ARCHITECT'S SUPPLEMENTAL INSTRUCTIONS

PROJECT:	The Residence at Carter Lake New Development Carter Lake, IA	Report No.	Seven (7)
OWNER:	OPG Carter Lake Partners, LLC Dan Maximuk 254 N. Santa Fe Ave, Suite A Salina, KS 67401	Date	February 23, 2026
CONTRACTOR:	Koester Construction Company 3050 SE Enterprise Dr. Grimes, IA 50111	Architect's Proj No.	25-3489
		Contract For:	General Construction Mechanical, Electrical

To Fit 11 7/8" LVL

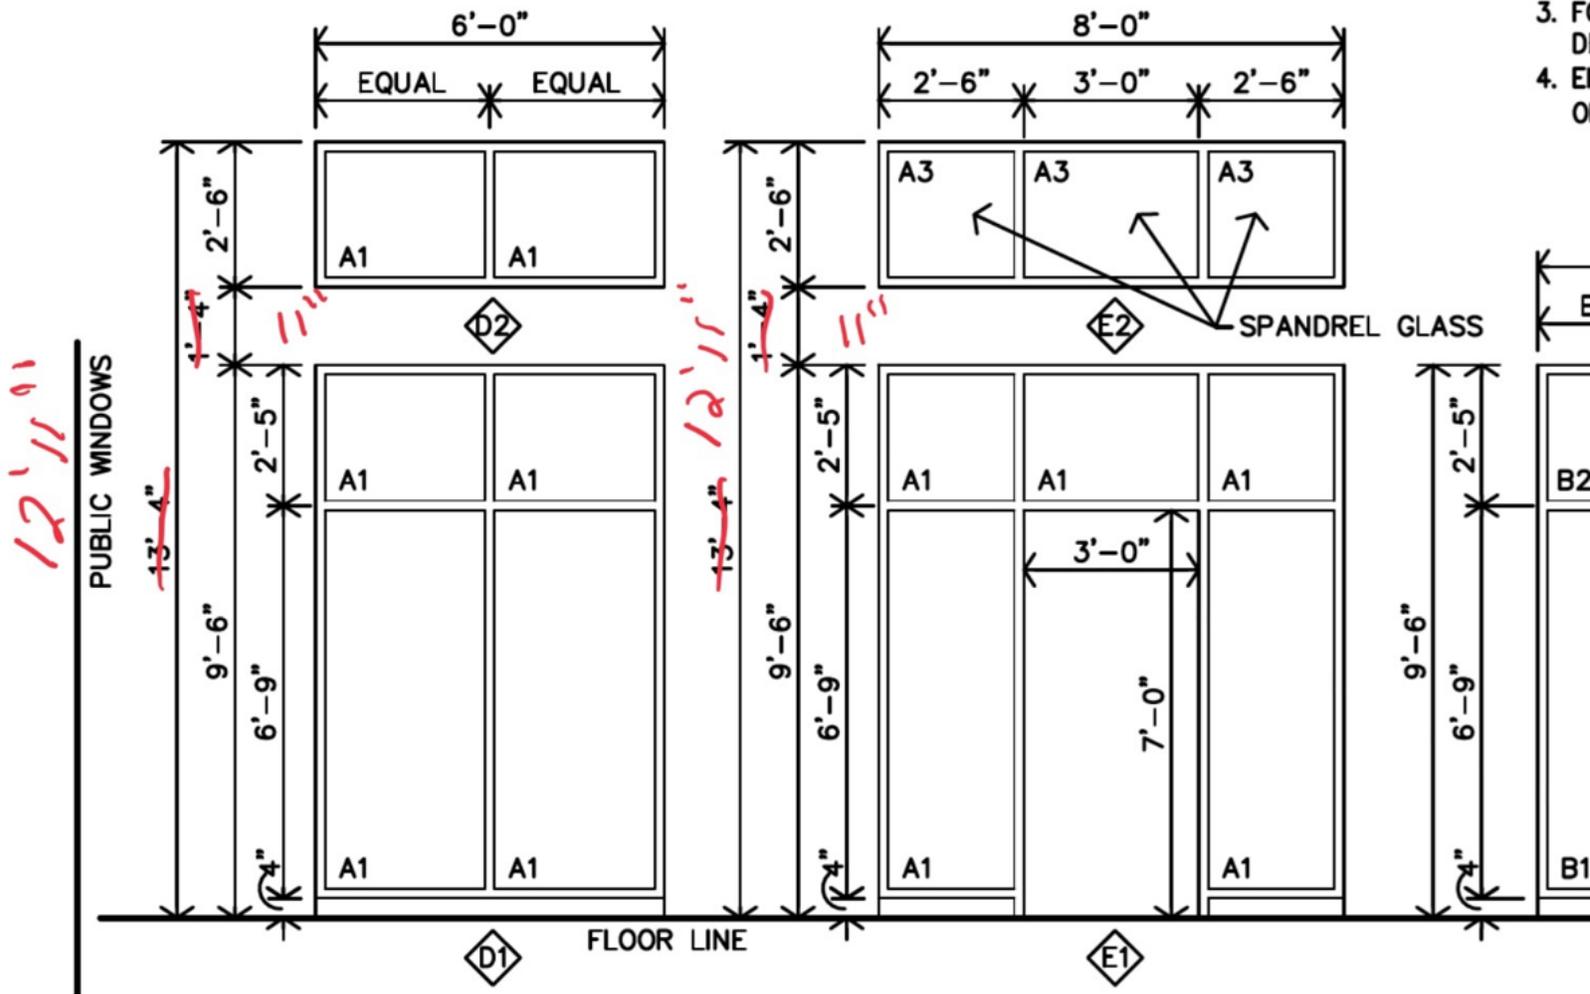
The trusses of the roof system are a different size in the structural plans than was drawn in the architectural drawings. This will require us to make an adjustment.

We will simply adjust the distance between the bottom of the upper transom to the lower window from 1' 4" to 11". This will not require any recalculations or engineering and we can use an 11 7/8" LVL.

A FIRST FLOOR PLAN

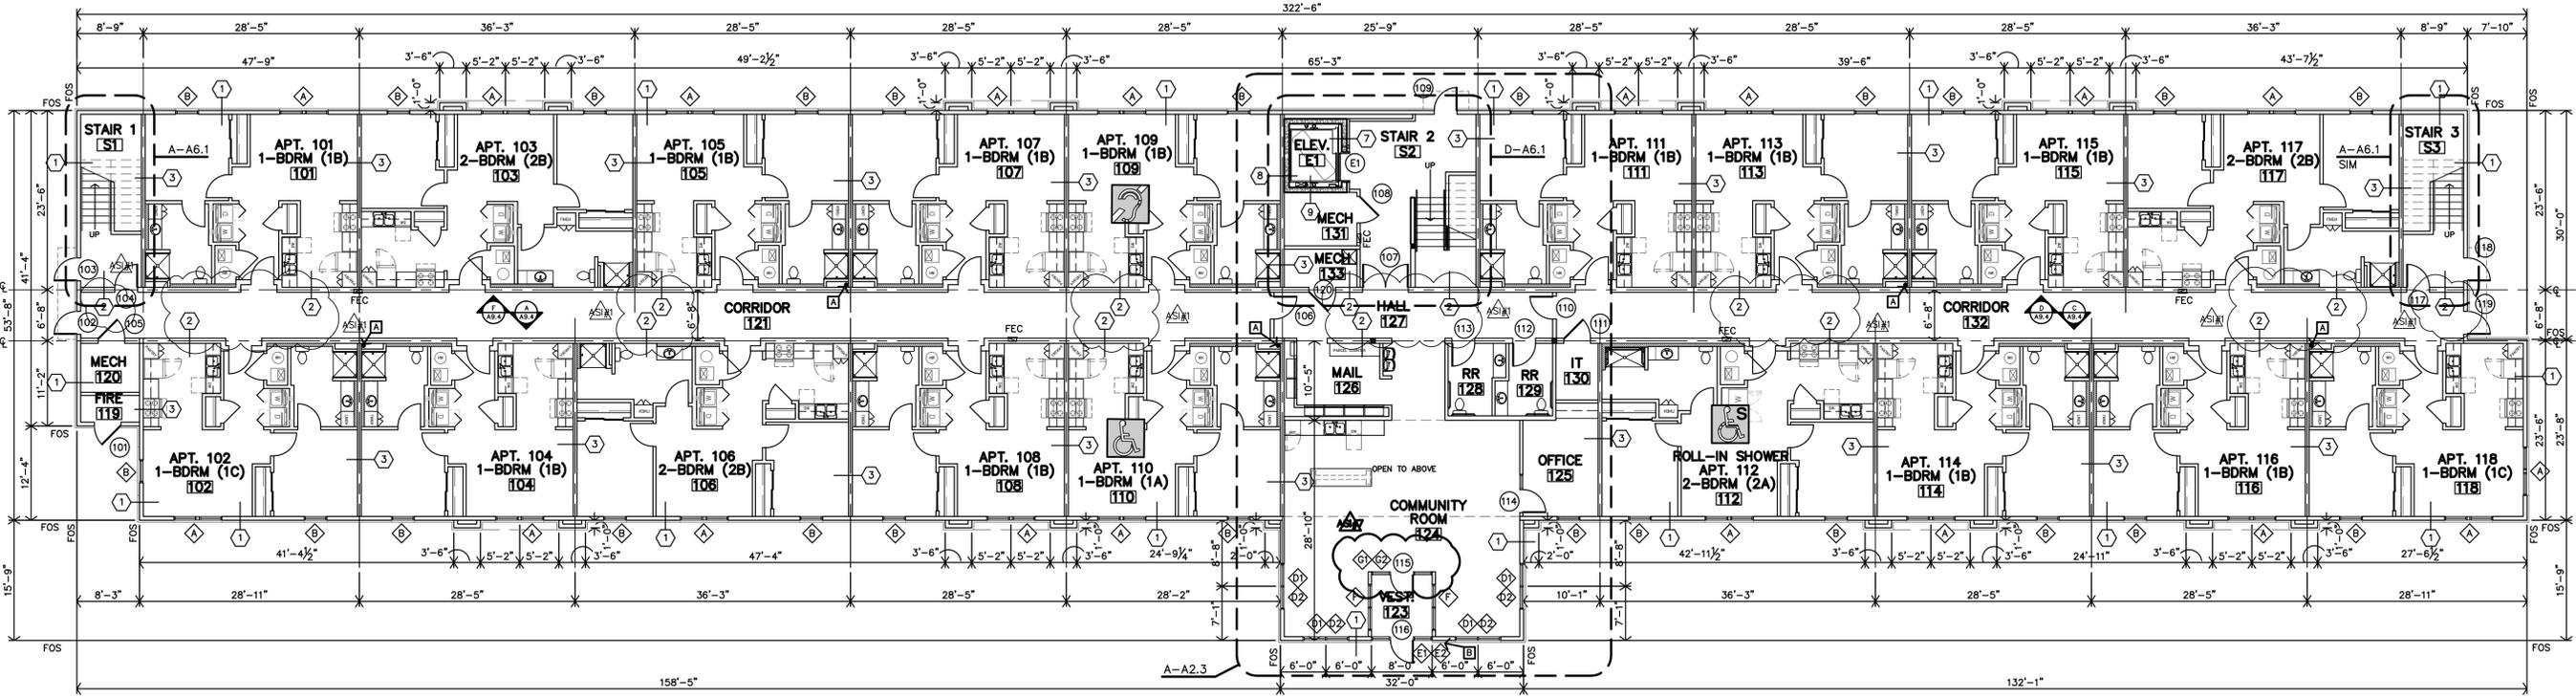
- 1) Sheets A2.1 & A2.3 – Window Type G2 has been added. Window Type G has been changed to G1.
- 2) Sheet A4.6
 - a. Detail D – Upper storefront window (D2) has been lowered 5" per contractor's email on 2/11/2026

SHEET NO.: A7.2

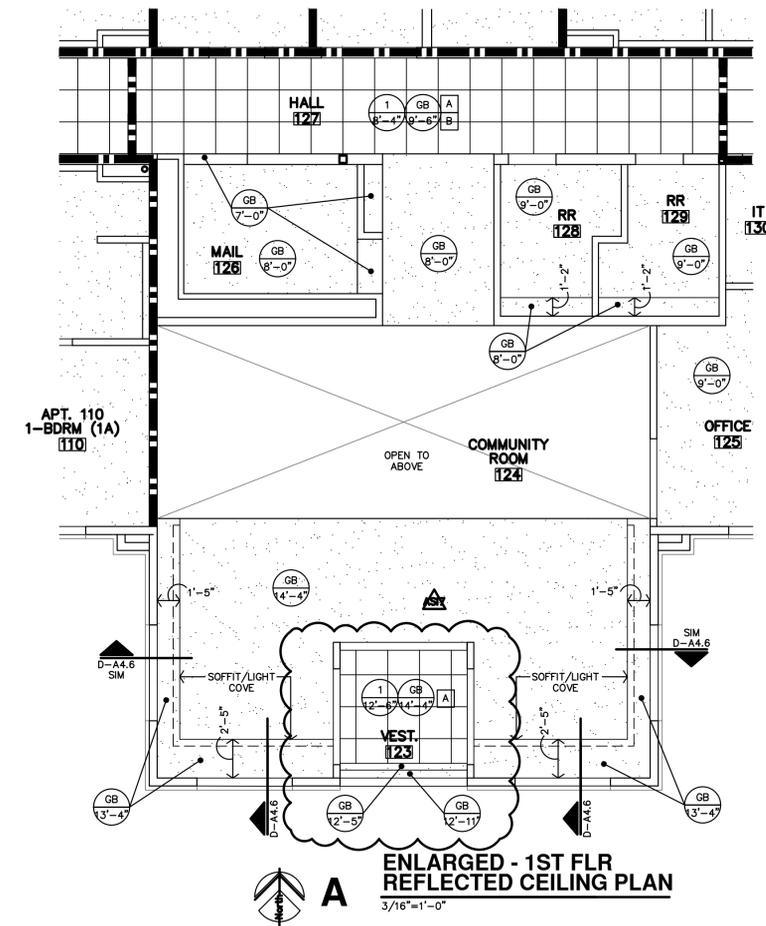
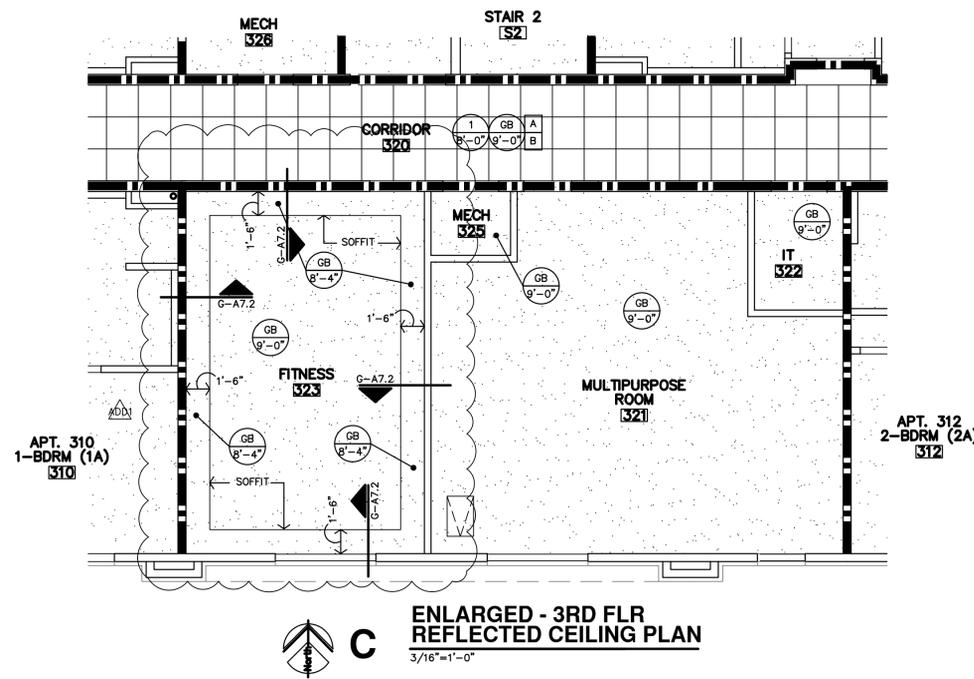
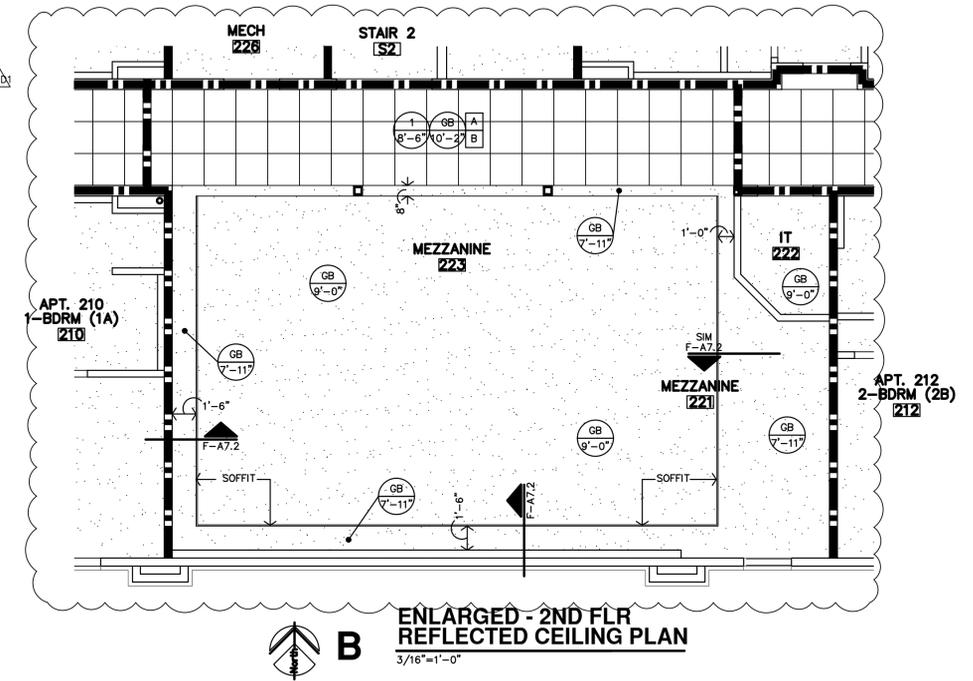
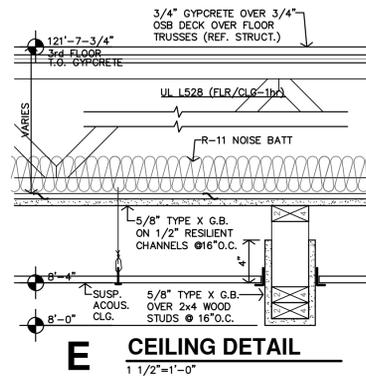
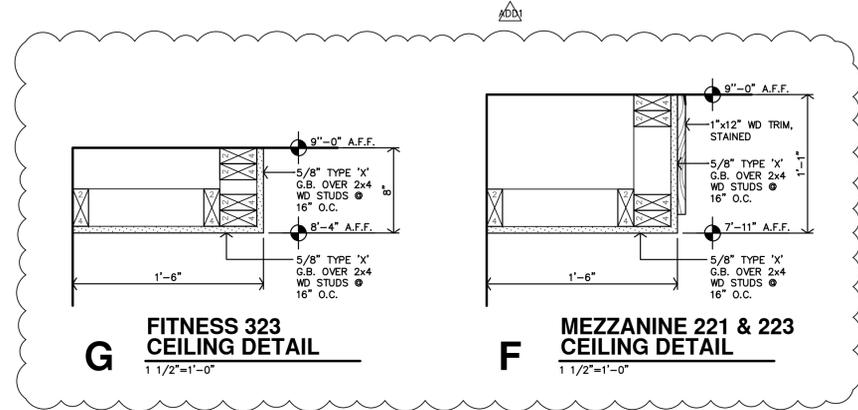
- 3) Sheet A7.2 – Vestibule 123 - Bulkhead has been added and ceiling heights have been adjusted.
- 4) Sheet A10.2
 - a. Window Schedule – Window Type 'G' has been changed to 'G1'. Window Type 'G2' has been added
